GROUP ENG	MODEL 2017-2018MY Forte (YDm) 2.0L MPI
	NUMBER 181	DATE December 2017
TECHNICAL SERVICE BULLETIN		
SUBJECT: SERVICE ACTION: IGNITION COIL OR COIL RFI SPRING REPLACEMENT FOR DTC P030X (SA321)

SERVICE ACTION: IGNITION COIL OR COIL RFI SPRING REPLACEMENT FOR DTC P030X (SA321)

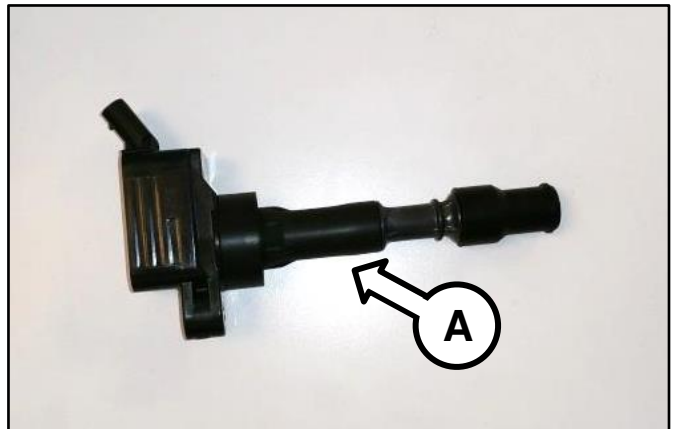
2. If a misfire (P030X) DTC is present, replace all four (4) ignition coils (A) with improved parts by referring to the “Engine Electrical System → Ignition System → Ignition Coil → Repair procedures” chapter in the applicable Shop Manual on KGIS then clear related DTC.

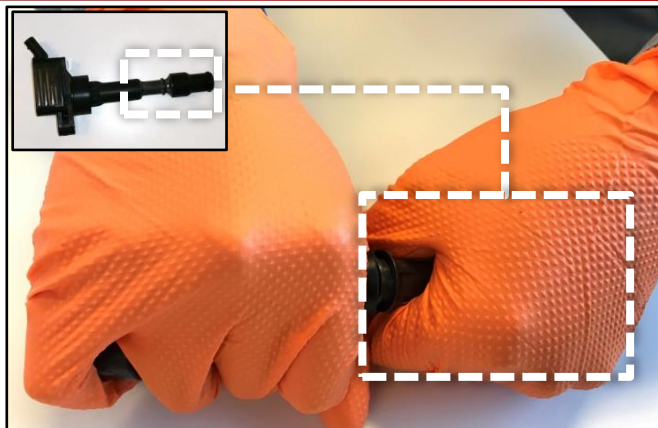
1. Remove the ignition coil (A) by referring to the “Engine Electrical System → Ignition System → Ignition Coil → Repair procedures” chapter in the applicable Shop Manual on KGIS.
2. With one hand, firmly hold the igniter part of the ignition coil (A).

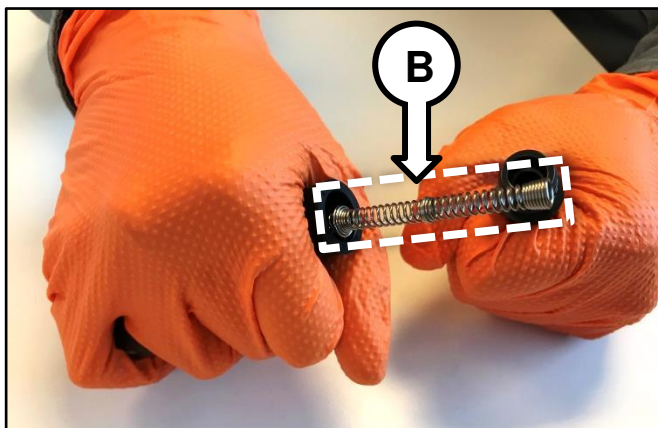
4. While firmly holding both ends, carefully wiggle and pull the ignition coil boot off from the igniter to expose the RFI spring (B).

5. Remove and replace the RFI spring with the new improved part.

Ensure the RFI coated end (C) is inserted first into igniter part of the ignition coil assembly.
